Project	IEEE 802.16 Broadband Wireless Access Working Group < http://ieee802.org/16 >	
Title	Changes on CDMA-based BW Request Procedures in OFDMA-PHY for Mobile Environment	
Date Submitted	2003-10-31	
Source(s)	Chulsik Yoon, Changwahn Yu, Kunmin Yeo, Byunghan Ryu ETRI 161 Gajeong-Dong, Yuseong-Gu, Daejeon, Korea	Voice: +82-42-860-6826 Fax: +82-42-860-6732 mailto: csyoon@etri.re.kr
Re:	This is a response to a Call for Comments IEEE 802.16e-03/23 on IEEE 802.16e-03/07r4	
Abstract	This document contains suggestions to the improvement of the CDMA-based bandwidth request procedures in OFDMA-PHY.	
Purpose	The document is submitted for review by 802.16e Working Group members.	
Notice	This document has been prepared to assist IEEE 802.16. It is offered as a basis for discussion and is not binding on the contributing individual(s) or organization(s). The material in this document is subject to change in form and content after further study. The contributor(s) reserve(s) the right to add, amend or withdraw material contained herein.

Changes on CDMA-based BW Request Procedures in OFDMA-PHY for Mobile Environment

Chulsik Yoon, Changwahn Yu, Kunmin Yeo, Byunghan Ryu
ETRI

Figure 2. Proposed CDMA-based bandwidth-request procedure in OFDMA-PHY for mobile environment.

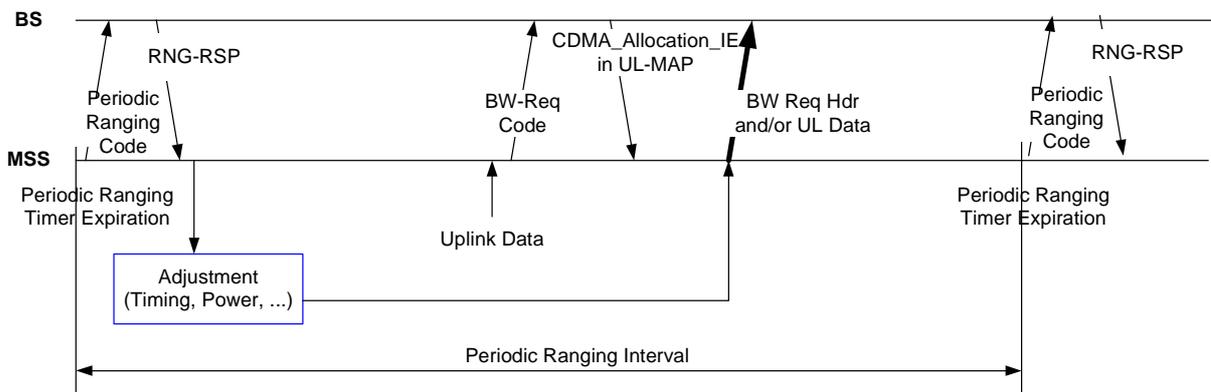
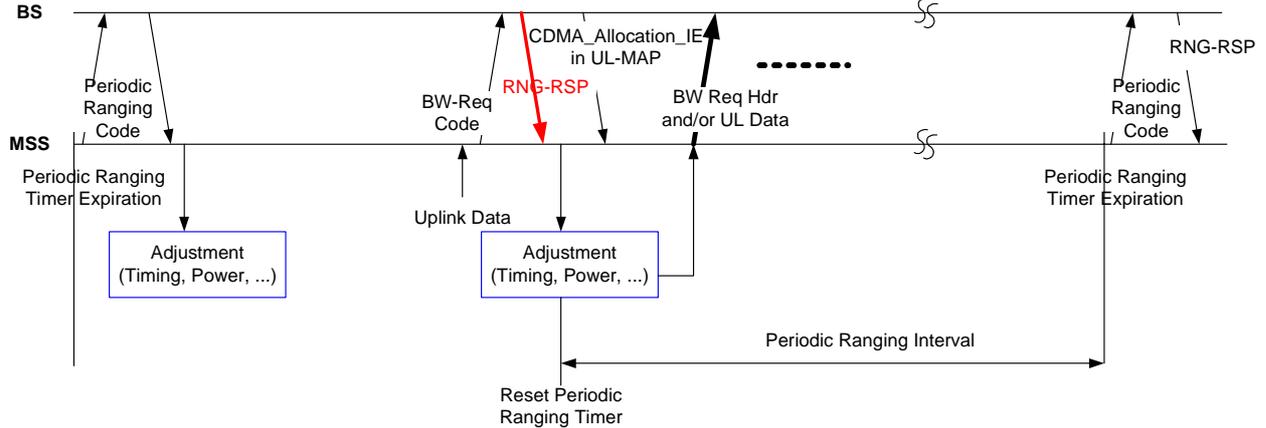
Therefore, we propose the unsolicited RNG-RSP transmission as a response to a CDMA-based bandwidth request before the CDMA_Allocation_IE in UL-MAP for uplink transmission to the MSS as an explicit procedure for a CDMA-based bandwidth request. Then the MSS can adapt to a more recent channel conditions (such as timing and power offset) and send uplink data using appropriate modulation and channel coding.

In Figure 1, we describe the current procedure for CDMA-based bandwidth-request in OFDMA-PHY. And, in Figure 2, we describe the proposed procedure for CDMA-based bandwidth request in OFDMA-PHY.

- The BS may send the unsolicited RNG-RSP as a response to a CDMA-based bandwidth-request. And if the allocation of a temporary CID to the user transmitting the bandwidth-request code is

enabled, the BS should contain the temporary CID in the RNG-RSP message in the Basic CID region.

- When the MSS receives a unsolicited RNG-RSP message after transmitting the bandwidth-request code, it shall reset the periodic ranging timeout, adjust the parameters (timing and power, etc.) as notified in the RNG-RSP message, and (if contained in the RNG-RSP message) allocate the temporary CID to identify the uplink resource allocation for it.

Figure 3. Temporary CID Allocation as a response to CDMA-based Bandwidth-request (Proposed).

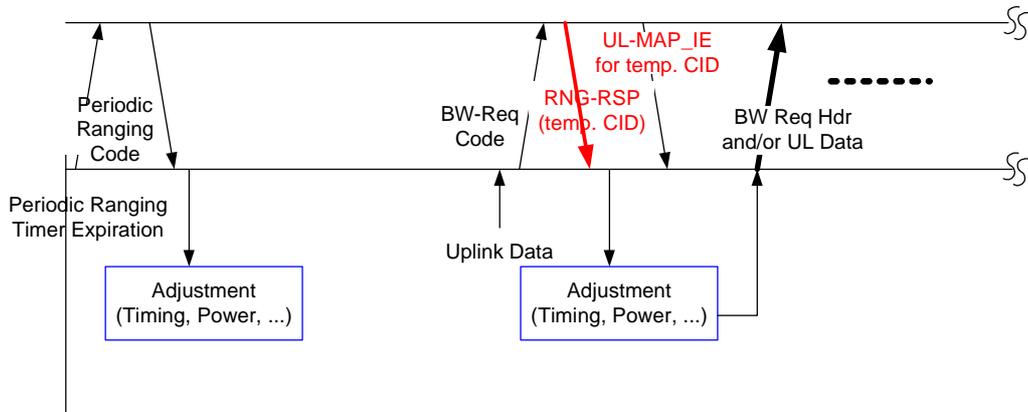
If we apply the unsolicited RNG-RSP to the CDMA-based bandwidth-request, information for discriminating the SS (frame number, slot number, subchannel number, code number, etc.) which is used to transmitted the bandwidth request codes are provided duplicated in the RNG-RSP message and CDMA_Allocation_IE, respectively. For reducing the overhead information designating the transmitting SS and maintaining consistency in the UL-MAP_IE format, we can provide temporary CID to the MSS in the RNG-RSP message. Then the BS can allocate the uplink resource to the MSS using the temporary CID, and the MSS can transmit the uplink data using the uplink resource allocated to the temporary CID. We describe the situation in Figure 3.
